# ANN ARBOR HISTORIC DISTRICT COMMISSION

## Staff Report

**ADDRESS:** 416 East Huron Street, Application Number HDC 14-085

**DISTRICT:** Old Fourth Ward Historic District

SHEET TITLE:  
**NEW ELEVATIONS**

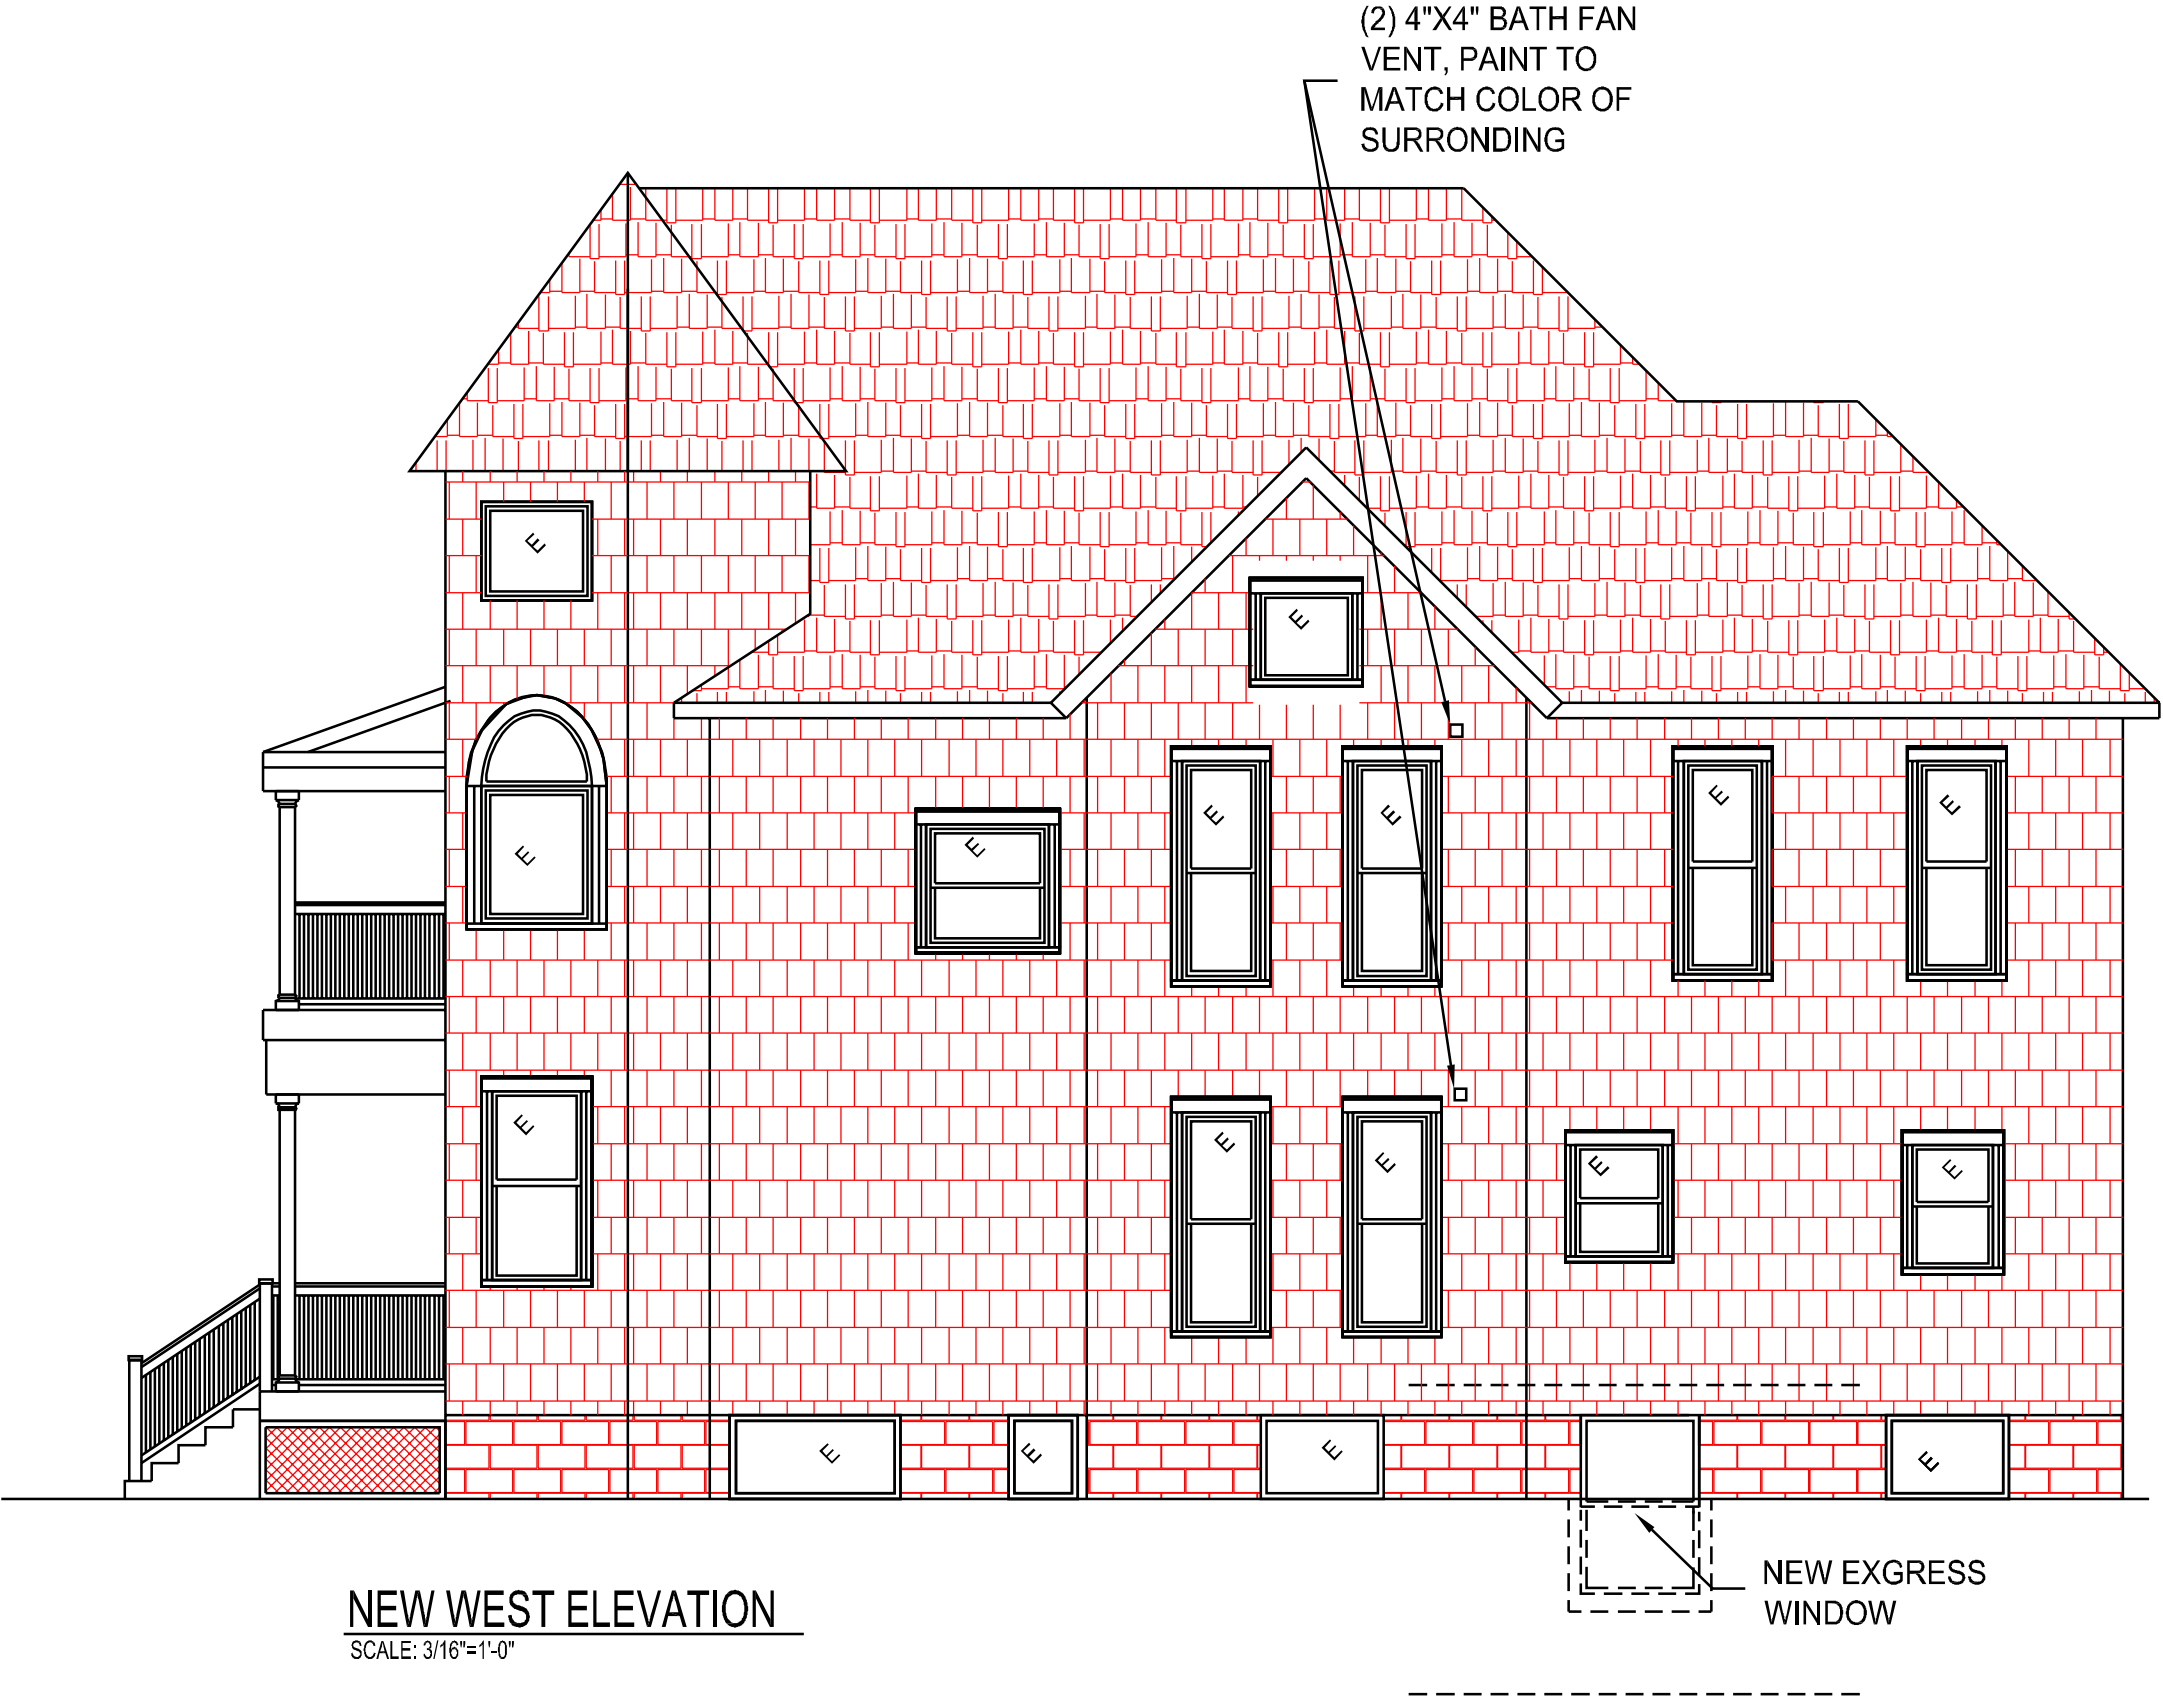
The property's historic use was as a single-family house. While the new use is still residential, converting it to housing for 18 people is much more intense. The required changes considered individually may be small, but collectively, seventeen vents on the

side elevations and roof, and three air conditioning condensers, are not a “minimal change”.

Staff collectively considers these seventeen vents and three condensers to be a negative alteration of the features of the house. Standard 9 says:

Pairs of PVC pipes extending out the side wall of the house and multiple other vents are not compatible with the historic materials, features, size, scale, and proportions of this historic Queen Anne house.

- 9. The work also does not meet the *City of Ann Arbor Historic District Design Guidelines* for Mechanical Equipment. The vents in particular detract from the historic integrity of the house.
- 10. In order to correct the application, staff suggests reducing the number of vents and condensers required, and reconfiguring vents to go through non-character-defining portions of the roof and rear elevation.

**NEW BASEMENT EGRESS WINDOW AND AREA WELL (ELEVATION)**  
 SCALE: 1/2"=1'-0"

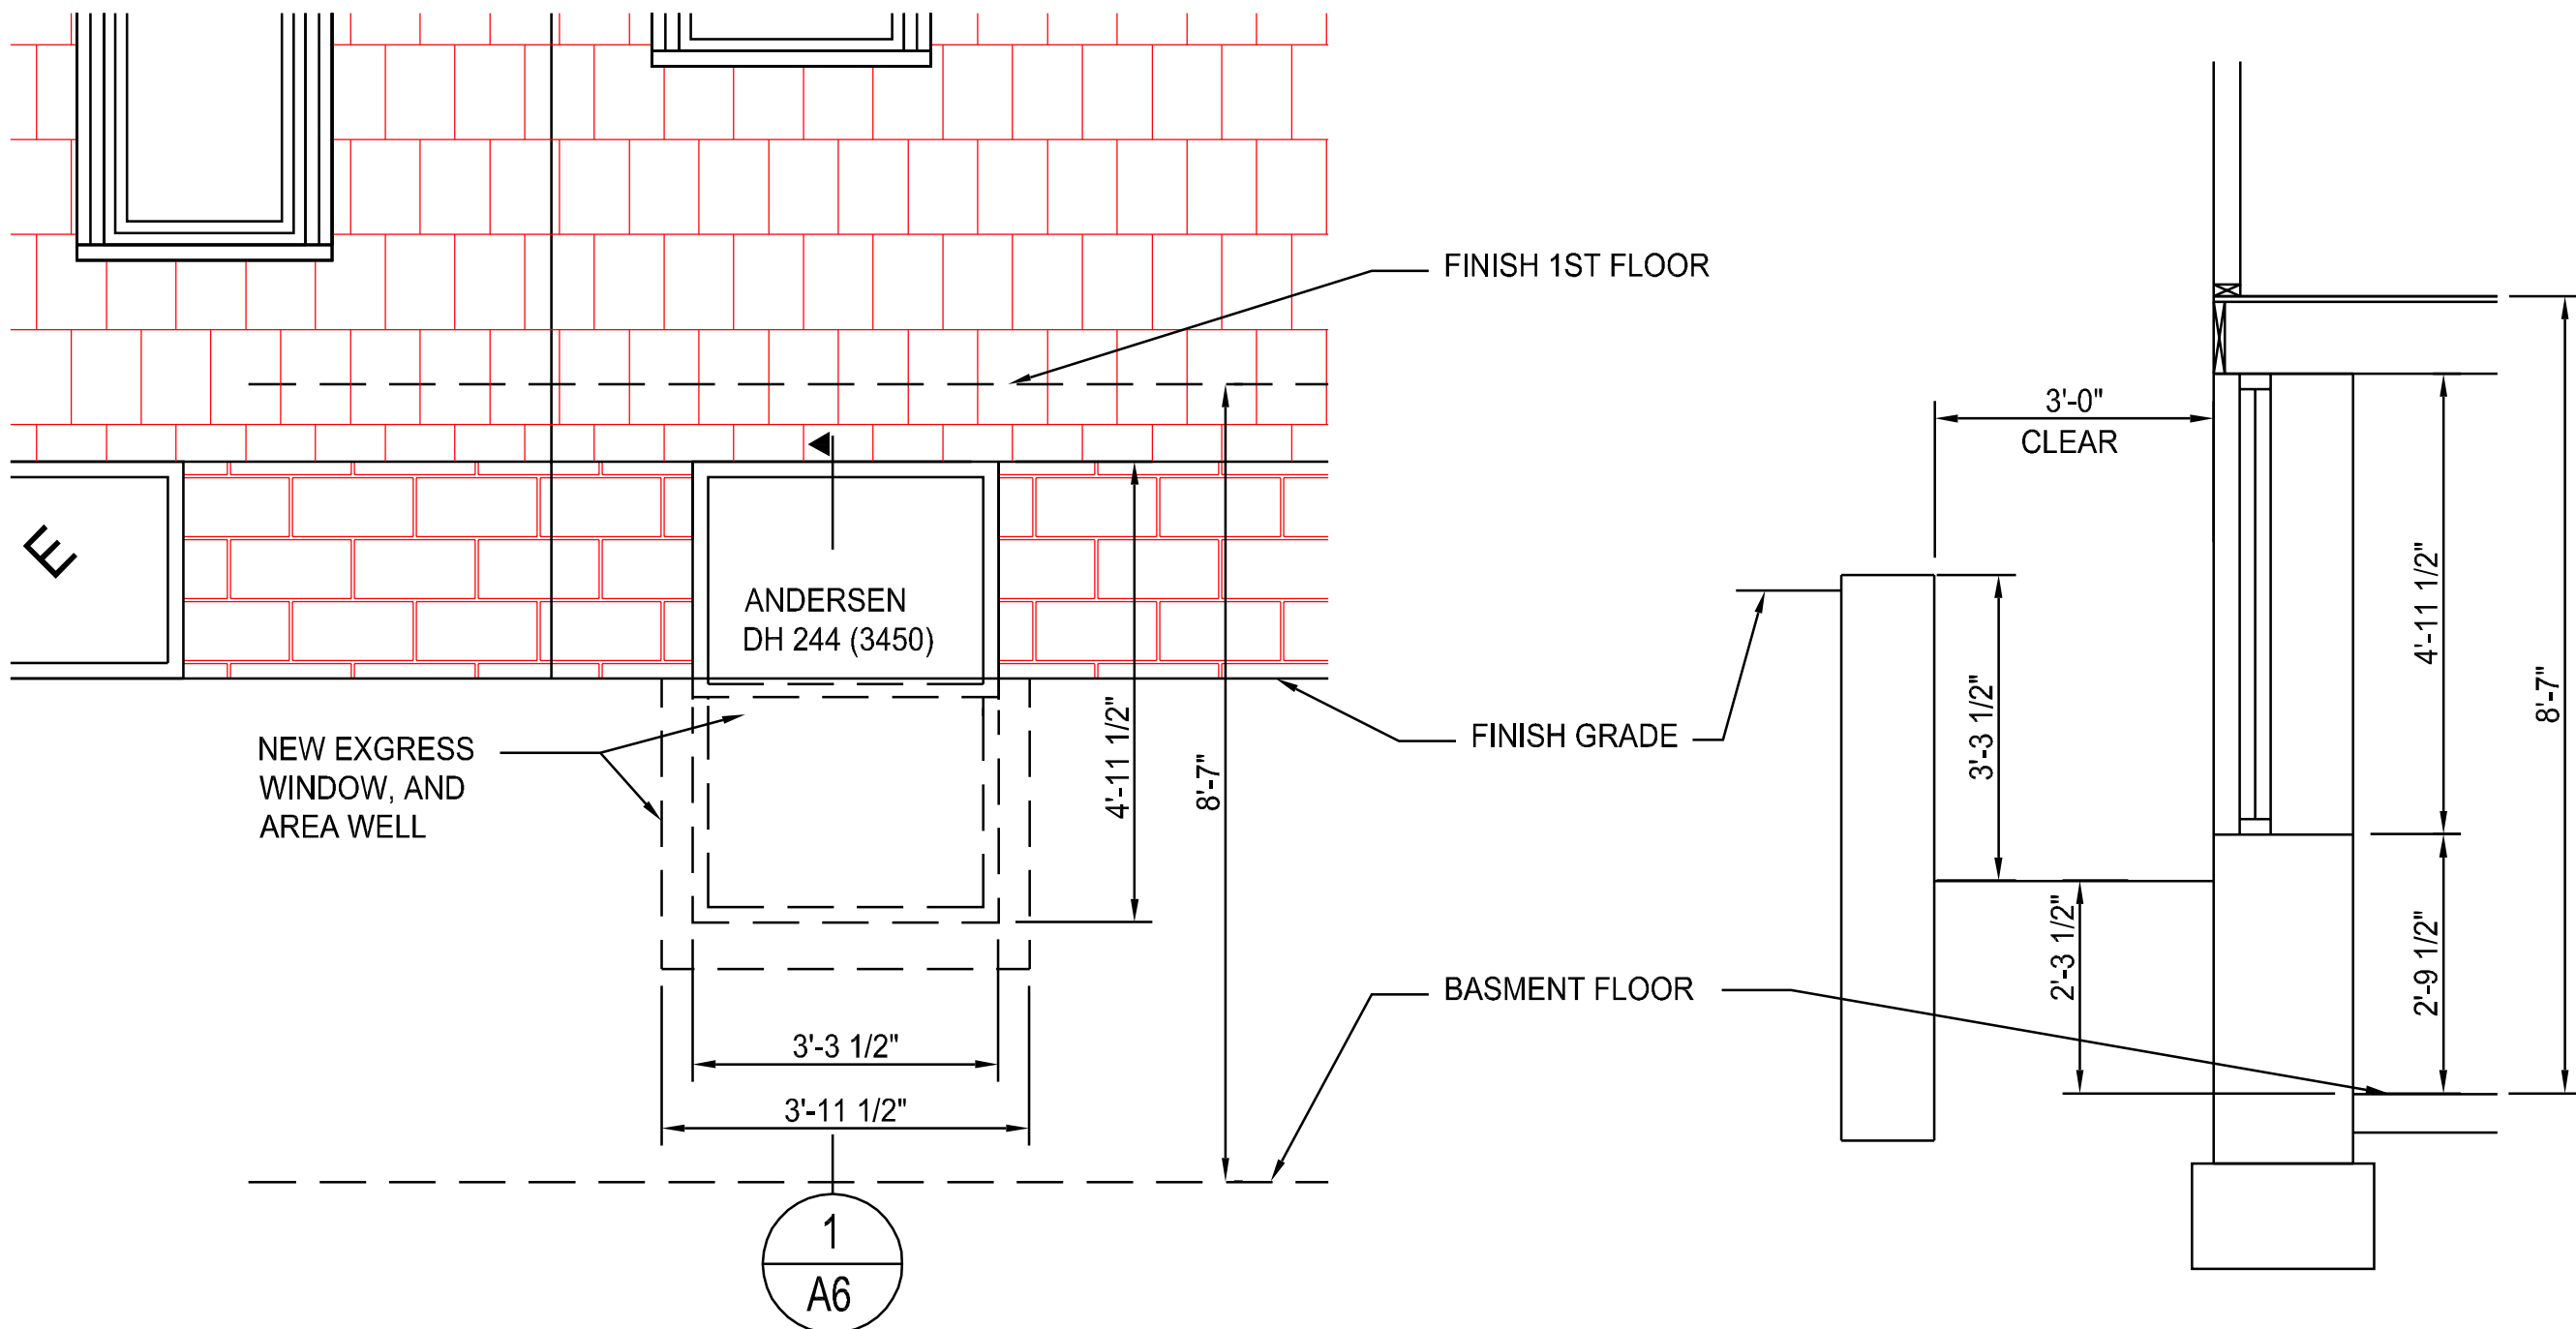
3. The egress window would be located near the back of the building and the width would match the width of the existing opening. One other egress window was previously approved by the Commission at the rear of the west elevation. The drawings supplied are contradictory and staff has requested revised drawings to clarify the size and well materials. If this egress window matches the one previously approved, it is an appropriate location for an egress window since it is near the rear of the house and probably not visible from the public right of way. If approved by the Commission, it is staff's opinion that no additional basement egress windows should be approved in the future unless they are on the rear elevation of the building.

I move that the Commission approve the portion of the application at 416 E Huron Street, a contributing property in the Old Fourth Ward Historic District, to install one basement egress window and well, as proposed. The work is compatible in exterior design, arrangement, texture, material and relationship to the rest of the building and the surrounding area and meets *The Secretary of the Interior's Standards for Rehabilitation and Guidelines for Rehabilitating Historic Buildings*, in particular standards 1, 2, 5, 9, and 10 and the guidelines for windows and health and safety, and the *Ann Arbor Historic District Design Guidelines*, in particular for windows and safety codes.
